RE: WWTF Improvements Project  
DNR Project No. 2014-0189A

Subject: Variance Request from 567 IAC 64.2(9) and Design Standards Section 16.3.1

**VARIANCE REQUEST**  
Iowa Department of Natural Resources

GRINNELL, IOWA  
WASTEWATER TREATMENT FACILITY IMPROVEMENTS  
PETITION FOR VARIANCE

Using these calculated clarifier loadings, the clarifiers would perform on the below curve as follows:

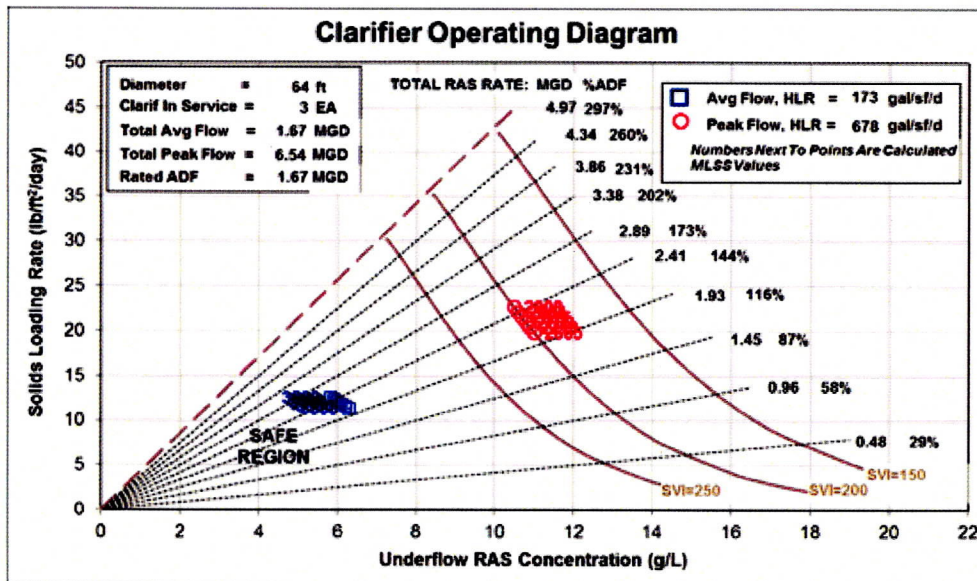
*20-30  $\frac{lb}{d \cdot sq ft}$  (Vesilind)*

(\*Please note that to be conservative, it was assumed all clarifiers only had a 10 ft side wall depth, when in reality the new 3<sup>rd</sup> clarifier would have a 12 ft sidewall depth)

From all of these scenarios, the manufacturers of the clarifiers plotted performance points onto their "Clarifier Operating Diagram", and all values fell on the "Safe Region" graph.

Please note that for simplicity and a conservative view, all 3 clarifiers were assumed to only have a 10ft SWD, while in reality, the 3<sup>rd</sup> new clarifier would have a 12ft SWD.

18. <u>Department's Justification:</u> Recommend variance approval. The information provided by the applicant indicates that the 10 foot deep clarifiers should provide equivalent effectiveness for solids settling for the WWTF.
